Item 4.**Development Application: 107-109 Darlinghurst Road, Potts Point - D/2025/1026****File Number:** D/2025/1026**Summary****Date of submission:** 27 October 2025 (Amended plans received: 27 May & 21 August 2026).**Applicant:** Mr Peter McGregor**Architect/Designer:** McGregor Westlake Architecture**Owner:** Raben Footwear Pty Ltd**Planning consultant:** Daintry Associates Pty Ltd**Heritage consultant:** Zoltan Kovacs**Cost of works:** \$10,234,400.00**Zoning:** E1 - Local Centre

Proposal summary: Consent is sought for alterations and additions to an existing mixed-use building above Kings Cross Station, including construction of 2 additional levels.

Figure 28: Contextual plan of projection over Darlinghurst Road

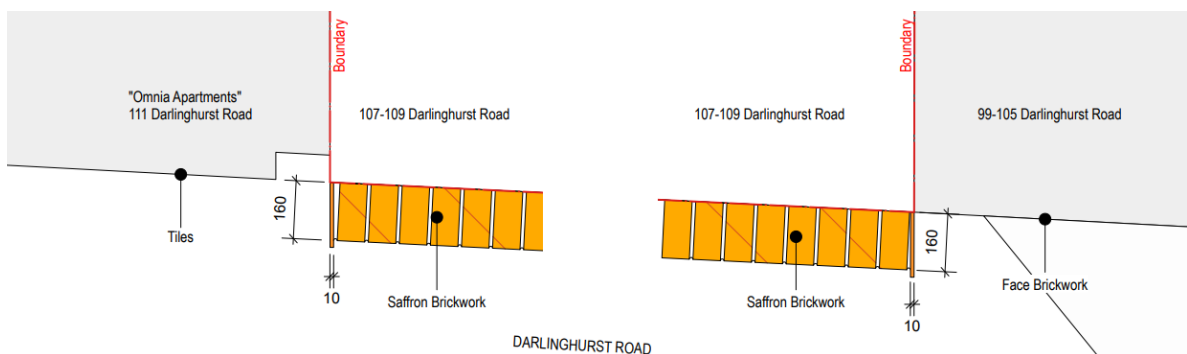
46. The proposed front elevation brickwork and windows in the front elevation extend 160mm over the front boundary above ground level. This encroachment is above the existing awning over the Darlinghurst Road footpath and is more than 3.2m above the footpath and more than 800mm from the face of the kerb. Furthermore, this element of the proposal will not result in adverse impacts on the amenity of adjoining property. The encroachment however comprises more than 50% of the road frontage of the building. On the request of Council, the applicant submitted contextual information to demonstrate the relationship of the proposed development with the as-built buildings on neighbouring properties - Refer to the images below.

Figure 30: 3D perspective of the proposed development showing the 22m height plane

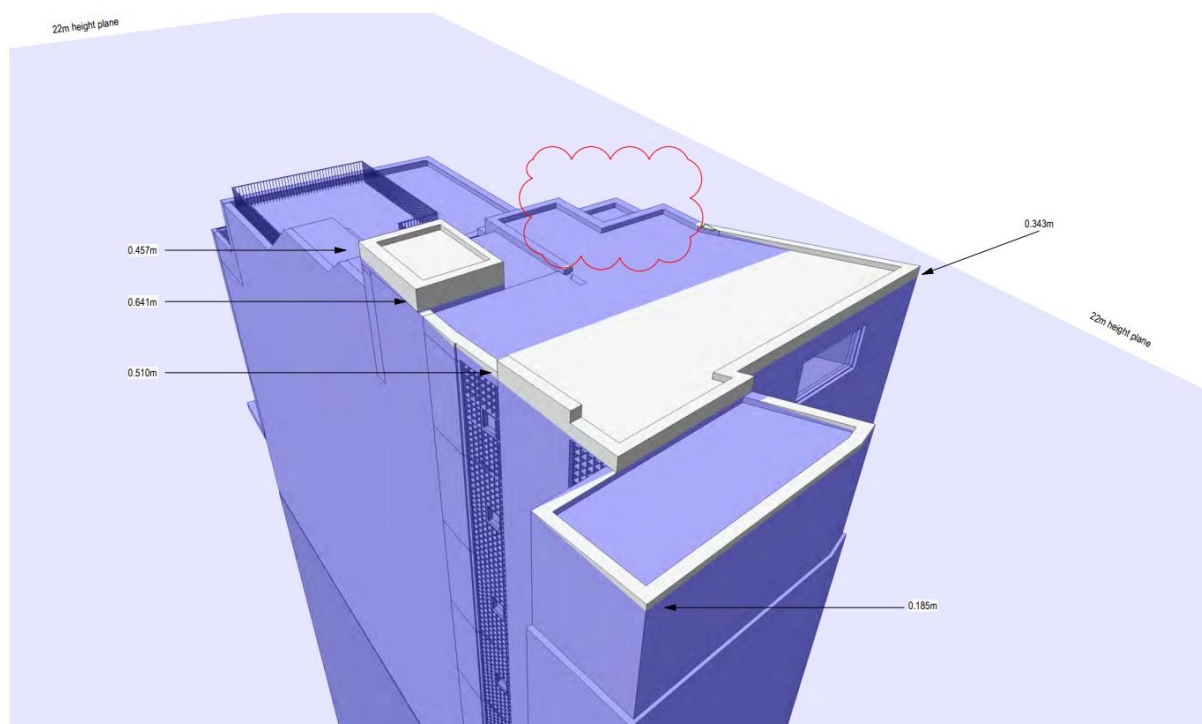
69. The site is subject to a maximum height of buildings control of 22 metres.
70. The proposed development has a maximum building height of 22.641 metres, representing a 2.91% variation of the height of buildings development standard applying to the site.

Figure 31: View from sun diagram at 9am, 21 June (Unit 4-12 living room window not visible)

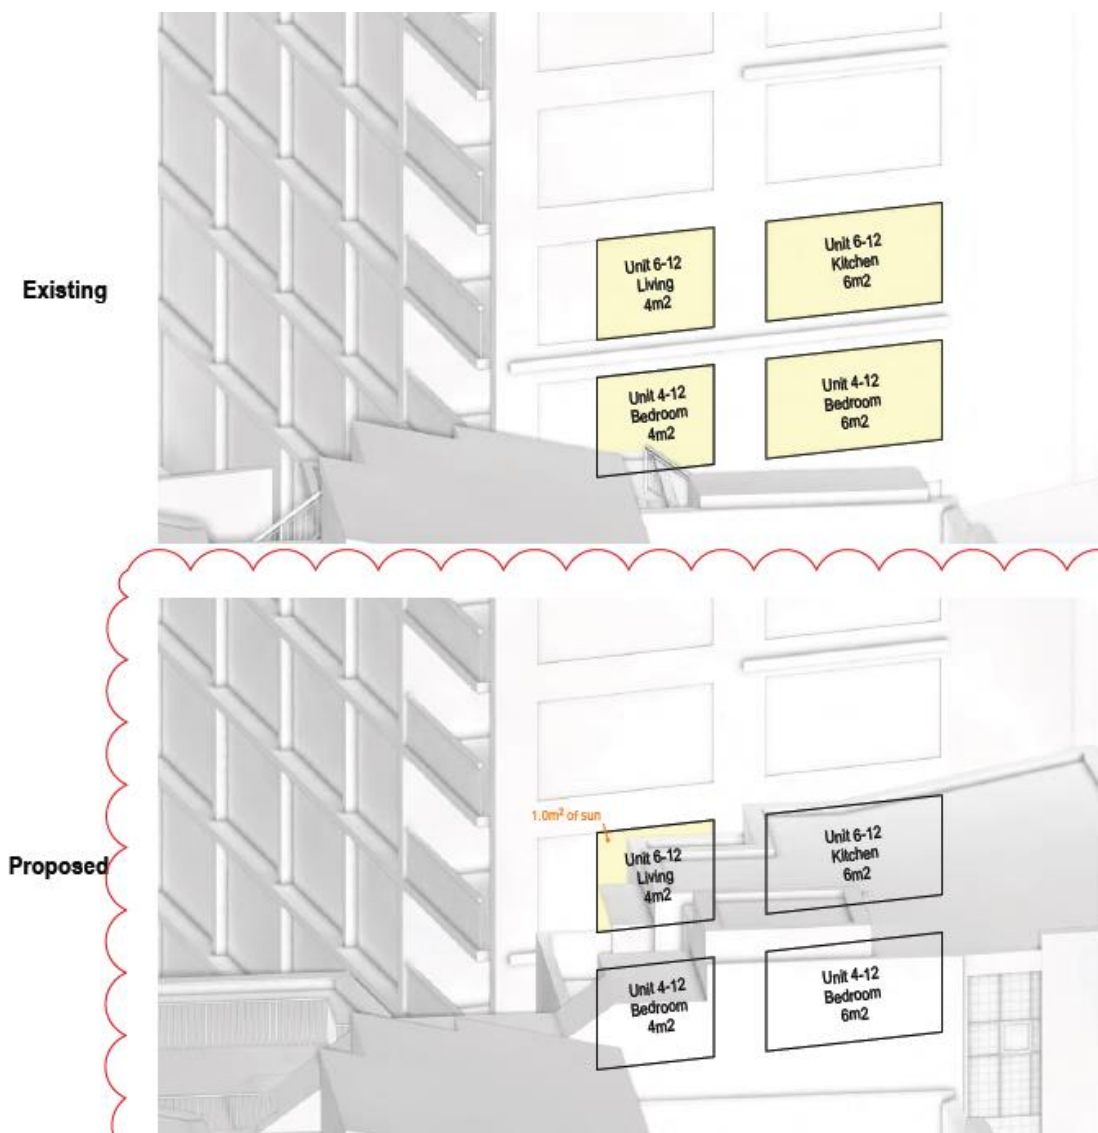
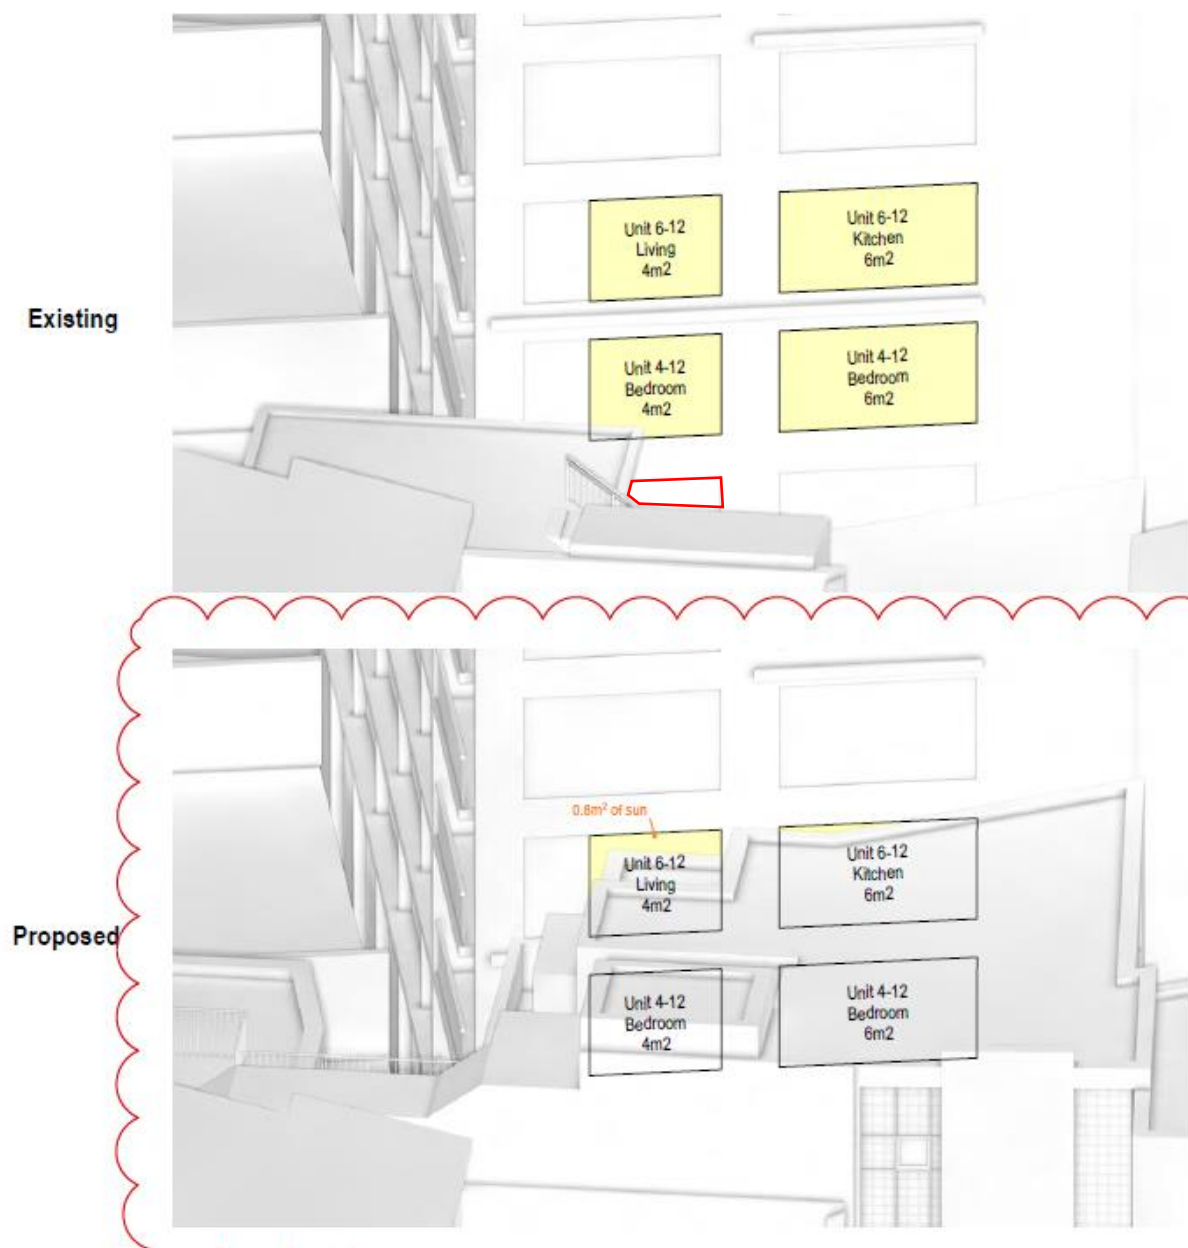
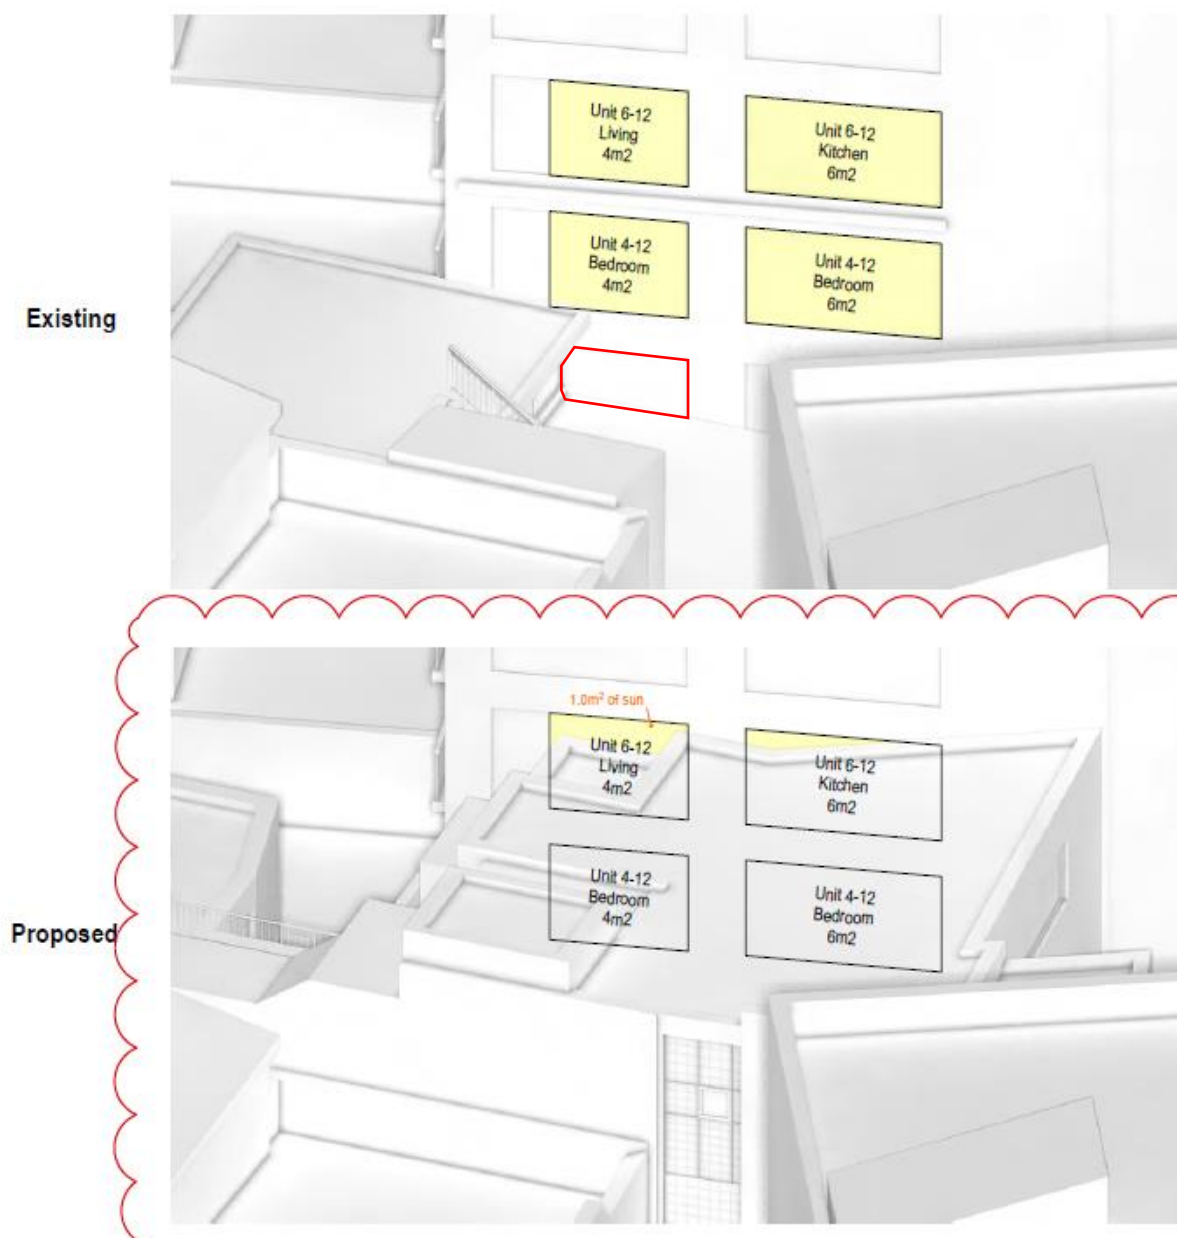
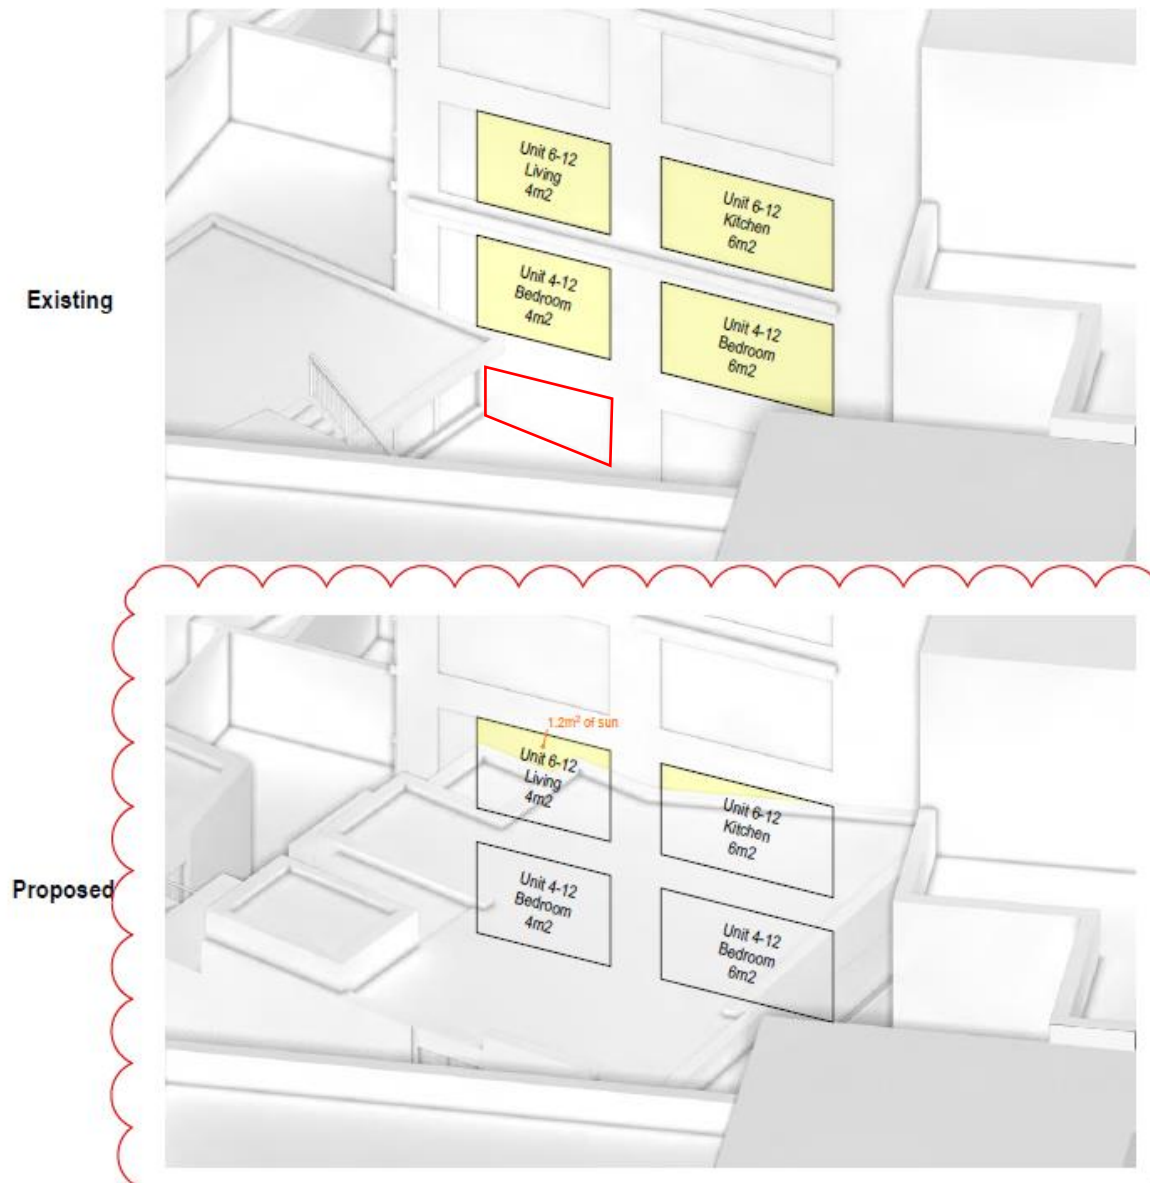
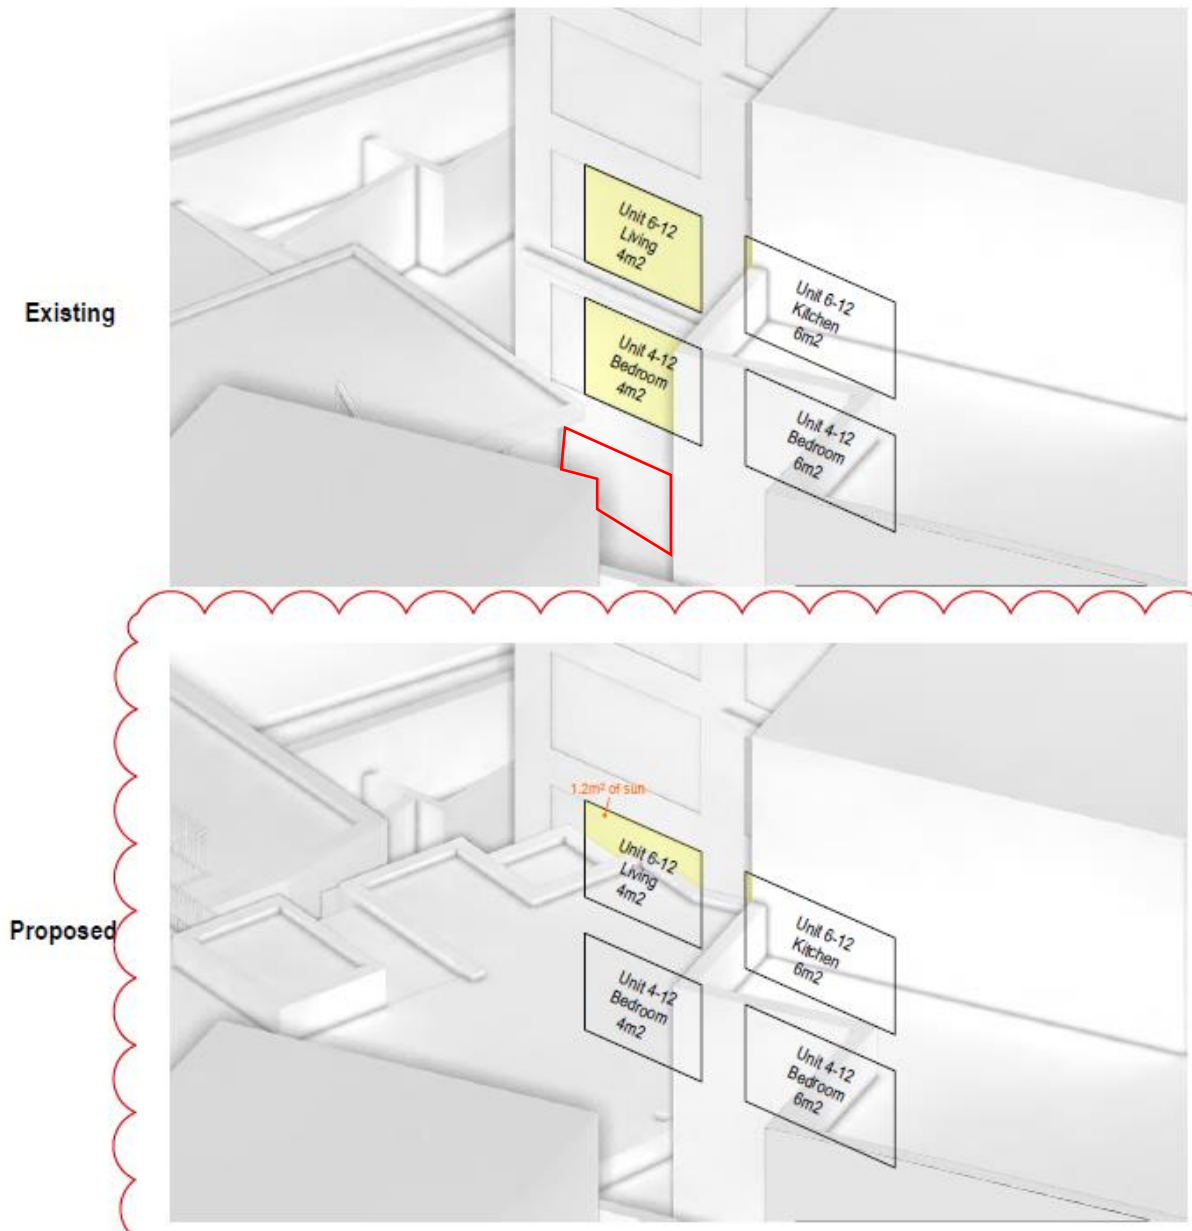
92. Unit 4-12 currently receives 2 hours' direct solar access to its north facing living room windows between 10am and 12 midday on 21 June.
93. The proposed development and additional two levels proposed atop of the existing building will block all direct sunlight to these living room windows currently receive between 9am and 3pm on 21 June resulting in a non-compliance with the provisions of the DCP.
94. Overshadowing impacts to this living room window are demonstrated by Figures 31-35 below, with the visible portion of the living room windows in question shown in red outline.
